Replacement MMIS Notification #4

October 28, 2011

Exhibit 4. CMS' Target Timelines for Different Business Areas to be completed in 2011

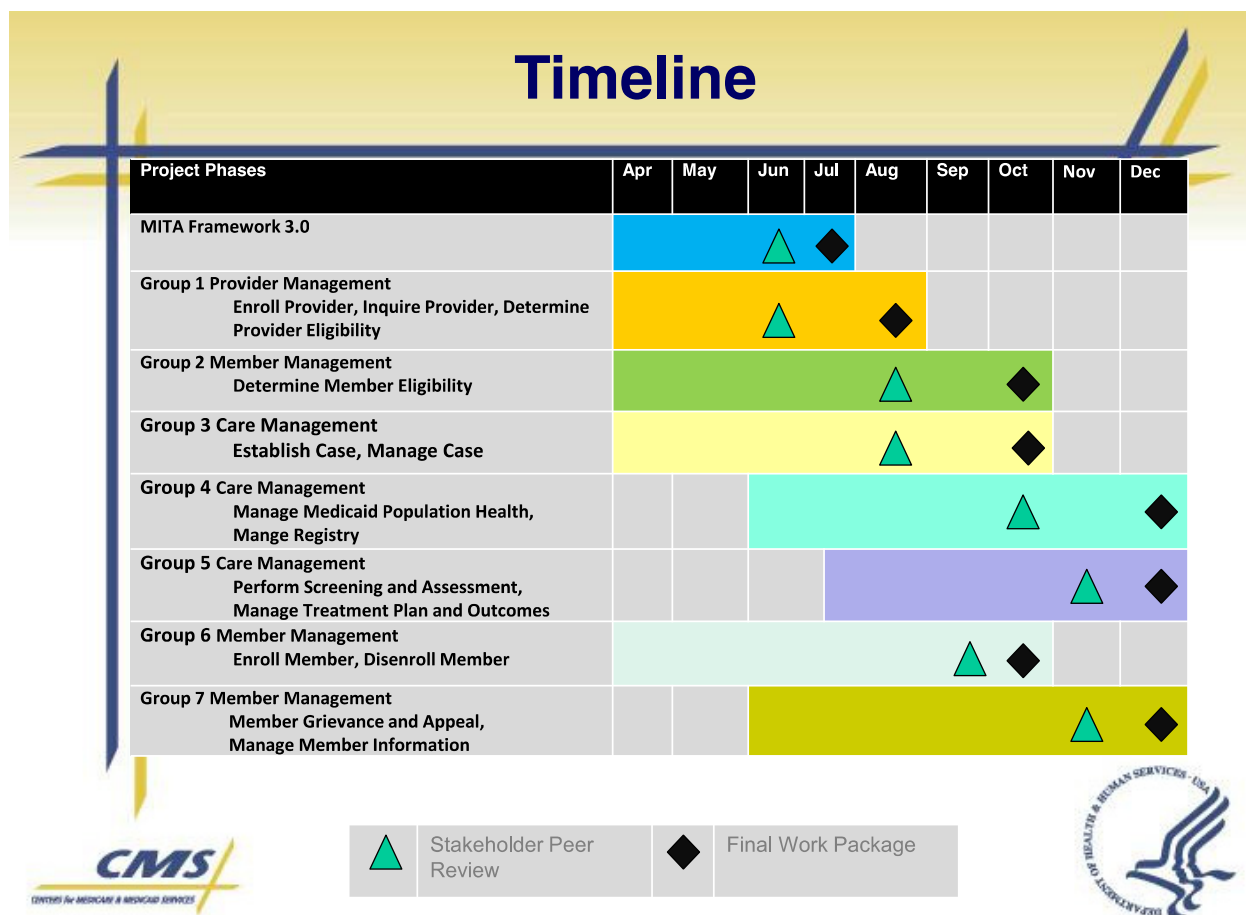
We recognize that there is a schedule risk of CMS not meeting its planned dates of December 2011 to publish MITA 3.0 specifications (please see Exhibit 4 for the CMS published timeline by the business process area). Further, there is a real risk that these specifications lead to additional questions, clarifications, and industry confusion. This vendor also recognizes that this will be a difficult undertaking for the vendor community given the evolving and undetermined specification of version 3.0. Having identified the risks associated with aligning the RFP to MITA 3.0, we believe that MMIS implementations are strategic investments and they need to be evaluated with the long-term strategic value to the State. This vendor recognizes that there is not a "one size fits all" solution to any given state business challenge or an MMIS implementation. The trade-offs concerning risks, costs, and schedule need to be balanced with any significant investment. Given the anticipated fundamental shifts in the healthcare industry, however, the multitude of initiatives (e.g., insurance exchanges, meaningful use) to be undertaken in the next couple of years, it is imperative that we embrace MITA 3.0. Based on a typical implementation timeline of 30-36 months, the state of South Carolina may be at a strategic disadvantage if it does not align with MITA 3.0 in some capacity.
